Subj: Comments on ENERGY STAR Windows Proposed Version 7, Draft 2

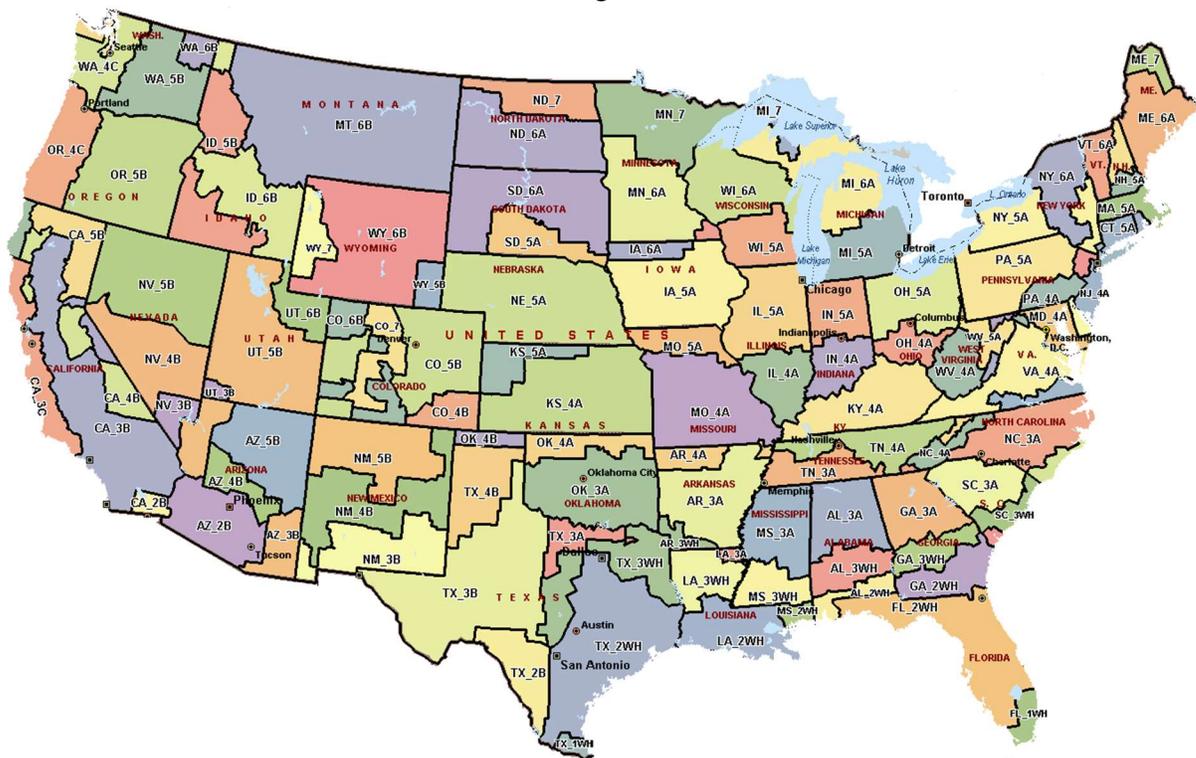
Here is the list of grouping errors in v7.2 that I have discovered:

- 32 regions with no representative location (example: North Carolina 4A and 5A)
- 14 regions where population is too high (example: MT_6A is 40% more than census)
- 12 locations assigned to the wrong region (example: Madison for Wisconsin zone 6)
- 8 regions with a low population count (my definition is +/- 10% of census)
- 7 duplicate locations in a region (example: Omaha and Scottsbluff for zone 5A in Nebraska)
- 5 locations that are not the regions' most populous (Pocatello versus Idaho Falls for ID_6B)

This totals 78 errors out of 132 locations in v7.2. No proportioning was done by EPA to include the new Alaska zones 5 and 6. Also, why is it that the "updated" ESW v7.2 map doesn't show anything for California zone 3C?

Alaska Regions

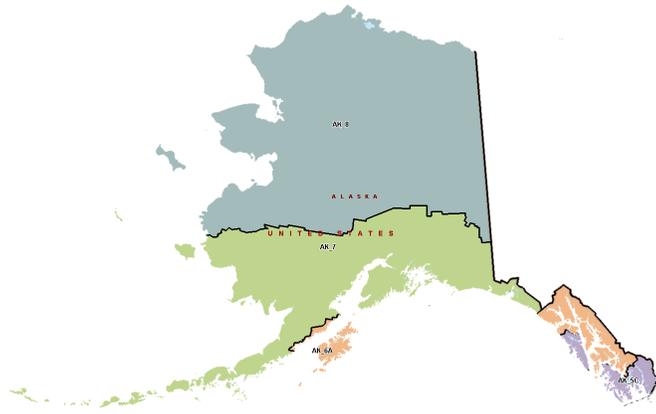
Following is a map of what the new region groupings look like for the Lower 48 and for Alaska. Note there where continuity gaps in NC_4A and NC_5a; I filled these in for better visualization.

Note that Alaska zones 5C and 6A are new for the 2021 code and where not considered in EPA's population weighting.

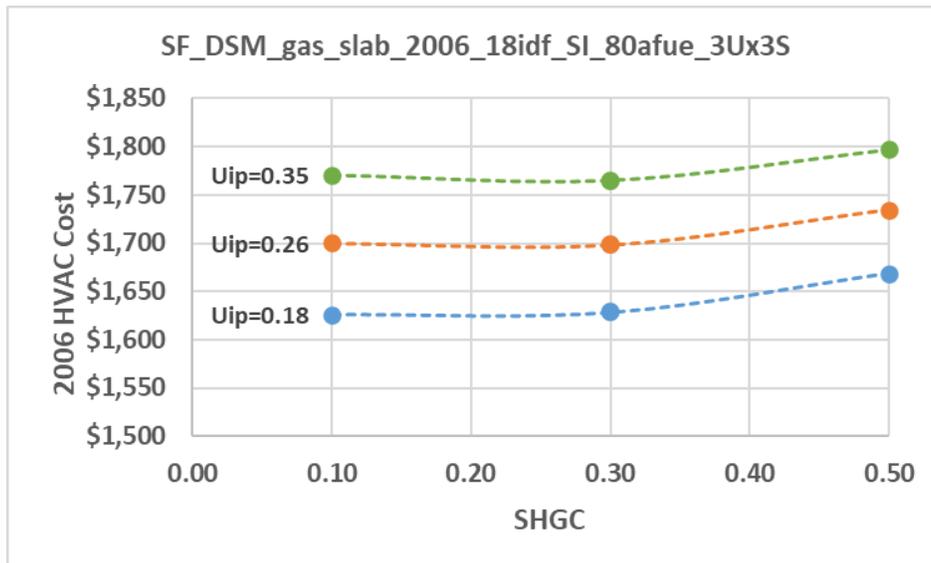
The following graph is a parametric analysis for a climate zone 5 example using trade-off **costs** from the ESW7.2 regional fuel prices. The upward slope with increasing SHGC suggests that, from the consumer perspective, high solar gain windows fail the proposed trade-off, for all window U-Factor's.

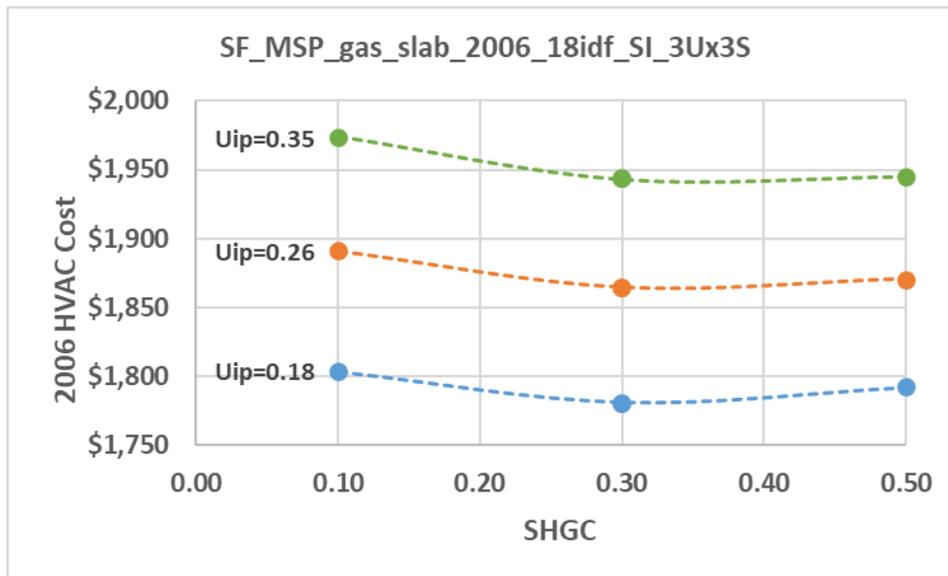
Moving on to zone 6 notice that the SHGC trend slopes down and that cost is optimized at about 0.30 SHGC. There are no additional savings for increasing SHGC beyond the optimum point.

A two-parameter linear analysis of the zone 6 data give us an equation of the form:

$$\text{Energy Cost} = \$1,647 + \$914 \cdot \text{Uip} - \$50 \cdot \text{SHGC}$$

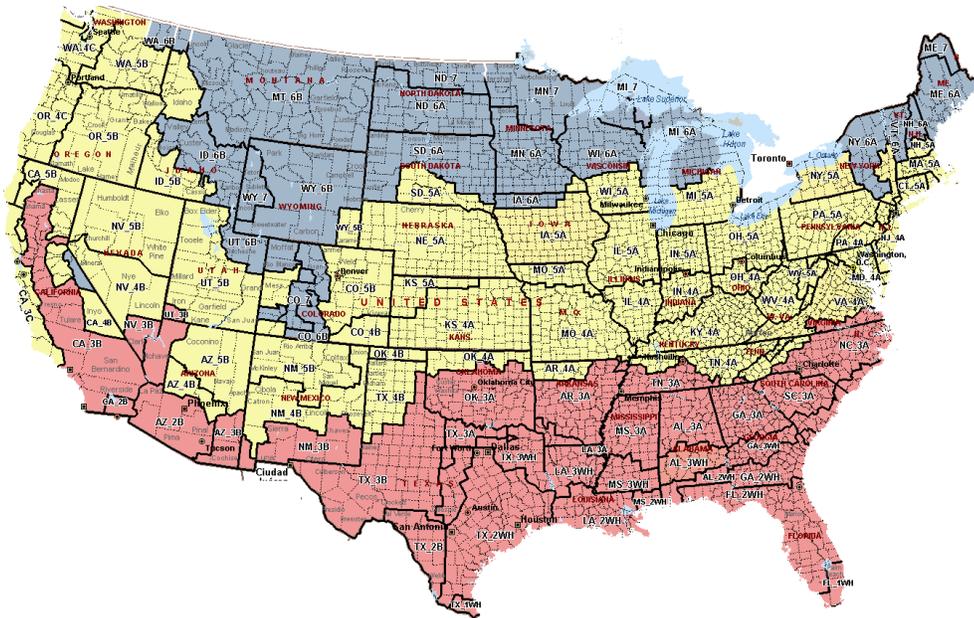
The colorization of the table above is intentional. Regression coefficients suggests similar window responses for zones 4 & 5; they are colored yellow to match the current North-Central window zone. Zones 6 & 7 get the blue zone coloration of ESW North as the window responses show passive benefits (albeit small in CZ6). When the population proportioning is correctly applied climate zone 5 represents 84% of the existing ESW Northern zone. How can CZ6 and 7, at only 16% of the Northern population, overpower the trade-off as the EPA grouping/analysis suggests? Climate zone 6 should be separated from CZ5 and grouped with CZ7/8. It's not shown in this table but regression coefficients from all locations suggest that the ENERGY STAR Window zones could be simplified to this:

<u>ENERGY STAR Zone</u>	<u>IECC Climate Zones</u>
North	6, 7, and 8
Central	4, and 5
South	1, 2, and 3

Here's a visual of the 3 zones:

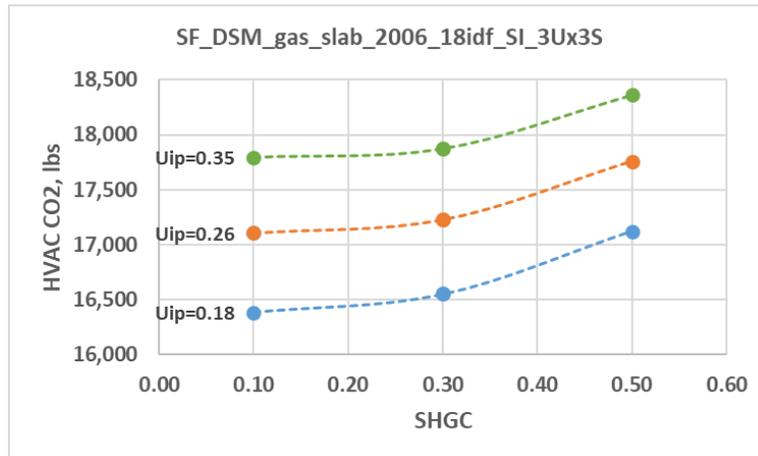
The next plot further demonstrates that the proposed SHGC trade-up in climate zone 5 fails the ENERGY STAR goal to reduce **emissions**. Compare this to the earlier plot on costs and we see that the upward slope on SHGC is even greater when CO₂ is considered.
